River Bend Station

Subject: River Bend Station - Unit 1
Docket No. 50-458
License No. NPF-47
Response to Request for Additional Information, Ampacity Derating
(TAC No. M85596)
File Nos. G9.5, G9.33.4

Responses to Request for Additional Information

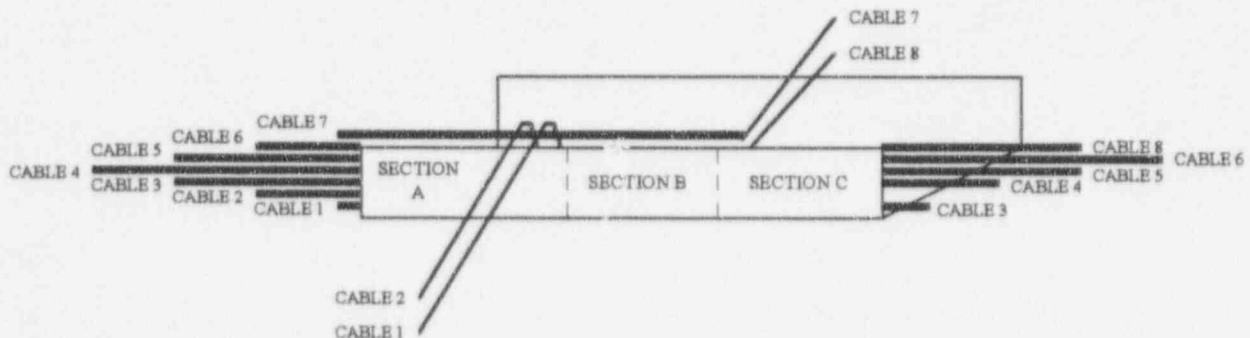
The licensee implies that the subject analysis will "calculate the depth of cables in each wrapped tray (other than control cables)" and will "use this value to determine an ampacity derating adjustment for cable depth." It is not clear whether those control cables which run in raceways with power cables will be included in depth of fill calculations. The staff agrees with our contractor, Sandia National Laboratories (SNL) that the thermal insulation effects of low or non-continuously energized cables must be accounted for in the subject analysis [see Attachment 1(a)]. The licensee is requested to clarify the use of subject assumption in the applicable calculations.

E-218, DRAFT Revision 1 and the associated PDMS ampacity computations do not use an assumed tray depth. The ampacity computation uses the results of the PDMS tray fill calculation to compute the ampacity of random lay cables in K (600 Volt power) and C (600 Volt control) trays. PDMS calculates tray fill by summing the cross-sectional areas of all cables in the tray, irrespective of cable type, and then dividing by the tray cross-sectional area. In K tray, control cables may be present with the power cables; PDMS includes these in the calculation. Therefore, the results of PDMS ampacity computations are based on tray fill (or depth) that includes all cables in the tray.

It is important to realize that the PDMS tray fill calculation is conservative because PDMS assumes that if a cable is in the tray anywhere, it is in the tray everywhere. The following figure and discussion explains this point.

Tray section A contains 7 cables (1 through 7), section B contains 5 cables (3 through 7), and section C contains 5 cables (3 through 6 and 8). None of the three tray sections contain all 8 cables. However, PDMS computes tray fill by summing the cross-sectional areas of every cable that enters or leaves the tray. In this example, PDMS computes tray fill based on the 8 cables in each of the three sections.
